# **Assessment of Blacktown City Council's Draft Section 94 Contributions Plan No 21**

Marsden Park Industrial Precinct

**Local Government — Assessment**  
September 2012

**MARSDEN PARK INDUSTRIAL PRECINCT  
WATER CYCLE MANAGEMENT FACILITIES  
BELLS CREEK STORMWATER QUANTITY**

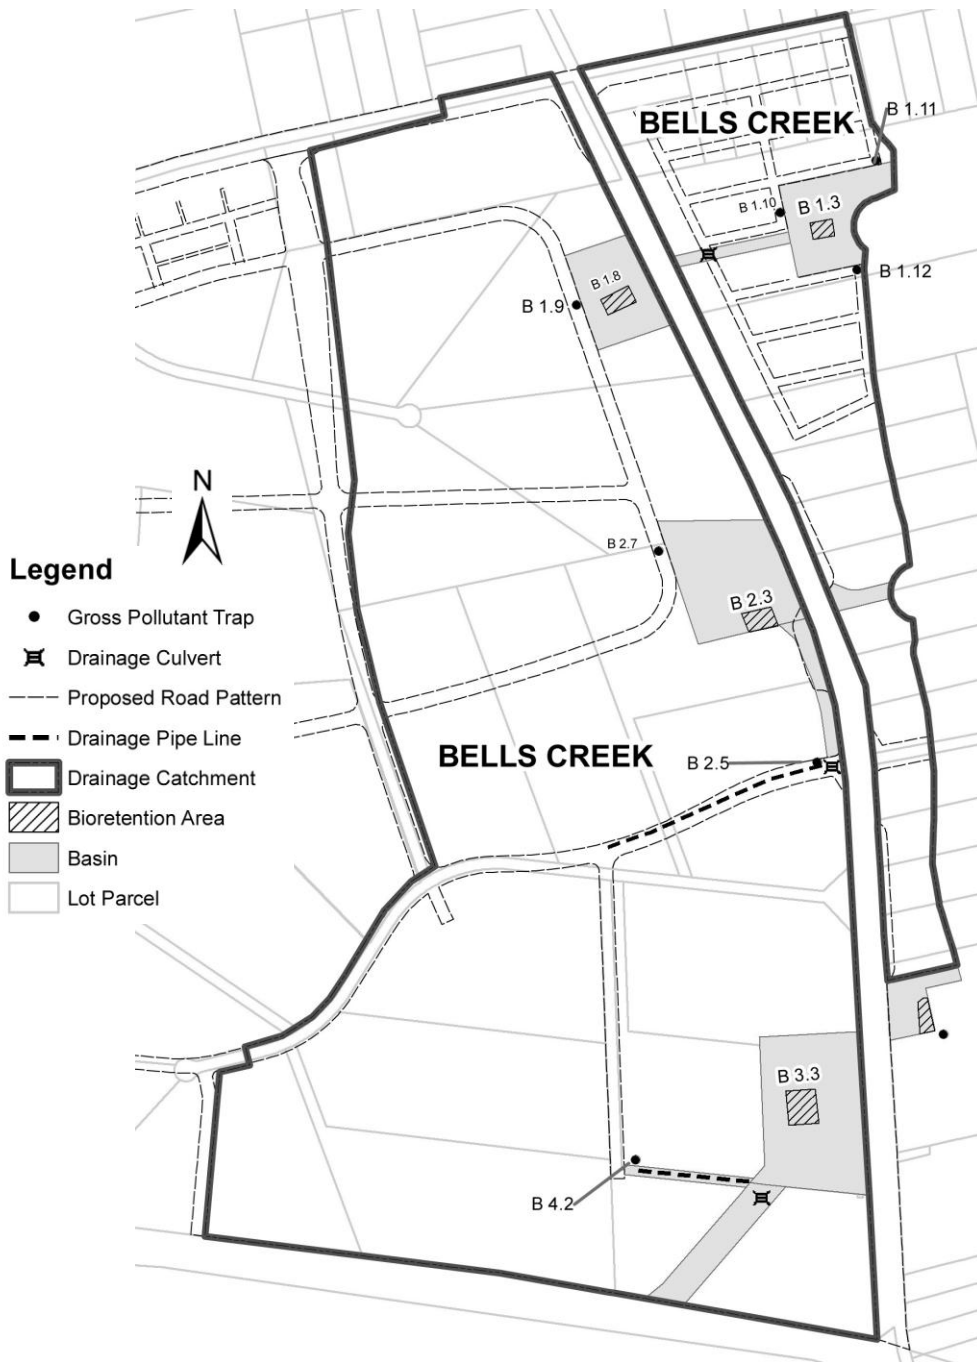
JWP Drawing Number Reference	Adjustment to the design	Comments & Recommendations
Plan No. 8955/SK6	B4.1 – Incorporation of a 210 m culvert with dimensions of 3.6 m x 0.9 m, to replace the proposed “Future 100yr capacity pipe” as described by JWP.	WP has no issue with the addition of this culvert as long as the carrying capacity is large enough for the design event. Given WP does not have the model to review, we cannot comment on the size of the culvert.
	B3.2 – Minor alignment change to basin. Addition of pipeline to the west.	WP has no issue with the changes as it is not seen to have any effect on the system.
	B5.1 & B5.2 – Addition of a Gross Pollutant Trap (GPT) and bio-retention basin at the outlet of Basin G.	The addition of the proposed works seems to be excessive. The proposed system currently has a treatment train reduction of 89% which does not meet the required 95% reduction of gross pollutants. The addition of a GPT would assist in the reduction of the gross pollutants to the required level. However, WP believes that the basin modification is excessive.

Plan No. 8955/SK7	B2.6 – Incorporation of a 460m pipe with an internal diameter of 1.35m to carry the stormwater flows from the new alignment of Hollinsworth Rd into Channel 12 and then into Basin I.	The proposed pipe would capture the 10.37ha catchment (B-3.1.00) and convey it to Basin I via channel 12 to be treated prior to outflowing into Bells Creek. BCC advised, during the meeting held in IPART offices, that they would request extra treatment for flows diverted into Bells Creek. WP has no issue with the addition of this pipeline to capture the runoff from the catchment.

**MARSDEN PARK INDUSTRIAL PRECINCT  
WATER CYCLE MANAGEMENT FACILITIES  
MARSDEN CREEK STORMWATER QUANTITY**

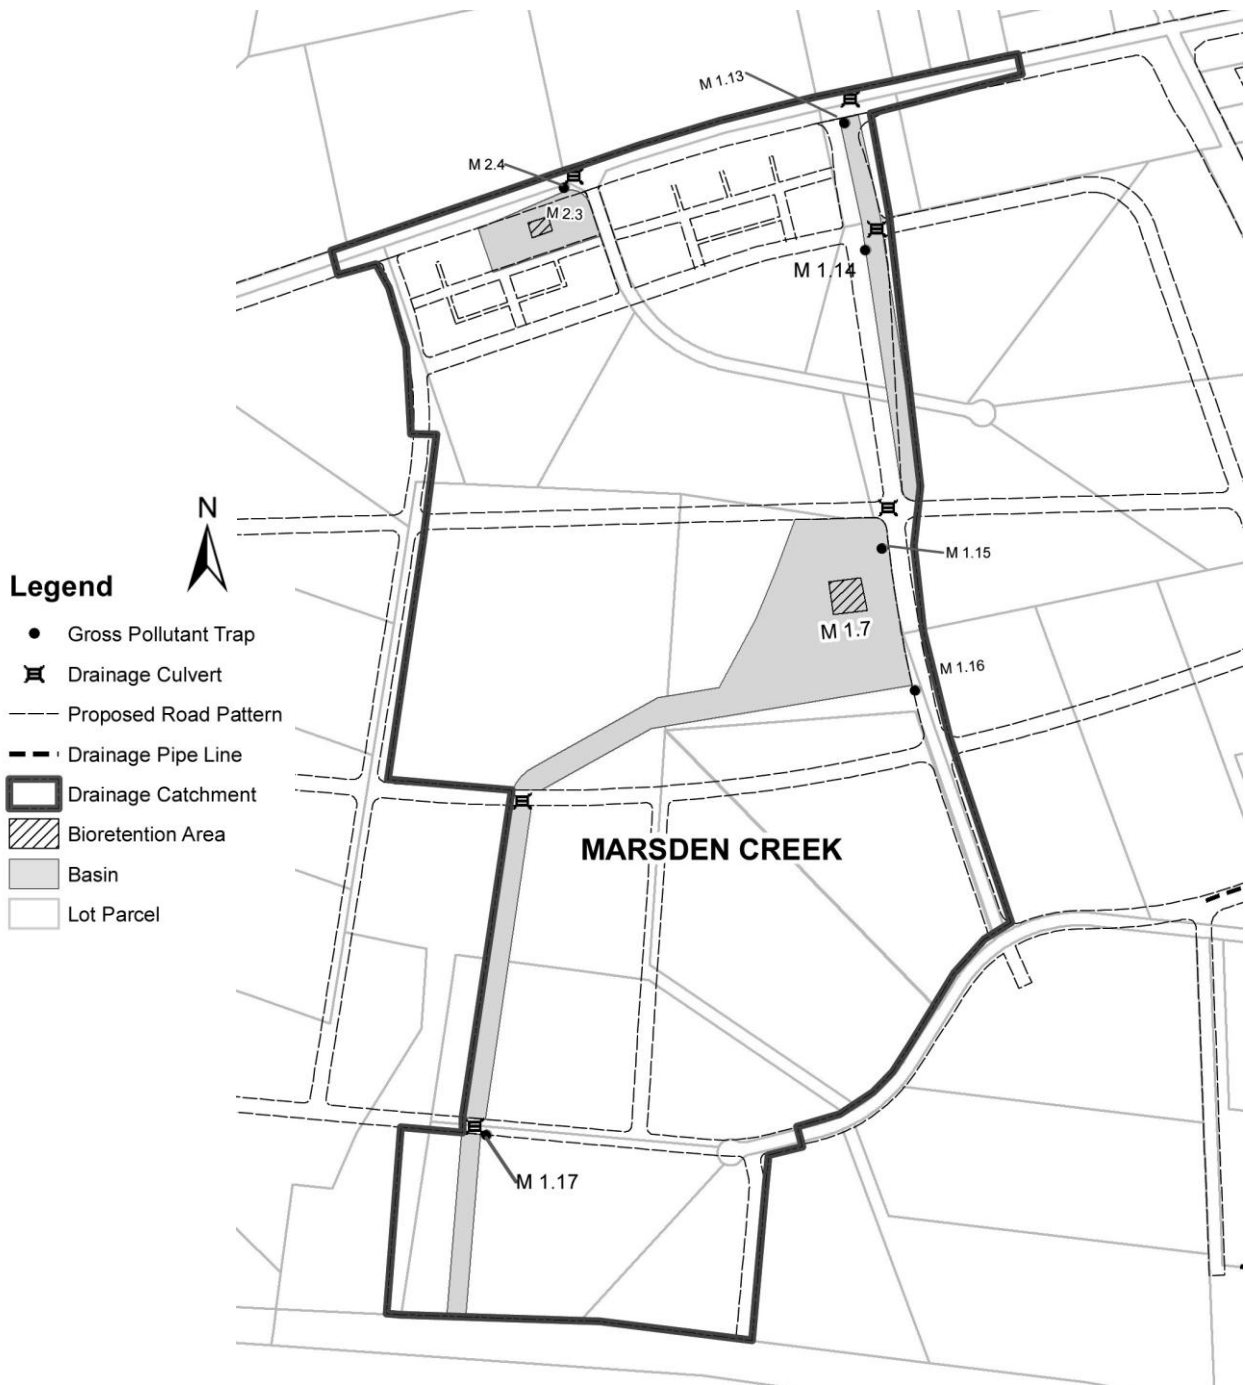
**Items M1.2 and M1.4 trunk drainage channels.** The land zoned for drainage purposes is not consistent with the sizing provided as the width tapers from zero to the required width over the length of the channels. It is not physically possible to maintain the channel capacity with this arrangement. Also Council does not accept the location of the drainage channel in the median of the proposed sub-arterial road due to operational grounds. The costs in the Contributions Plan allow for the open channel to run parallel with the sub-arterial road and includes additional land to facilitate this outcome.
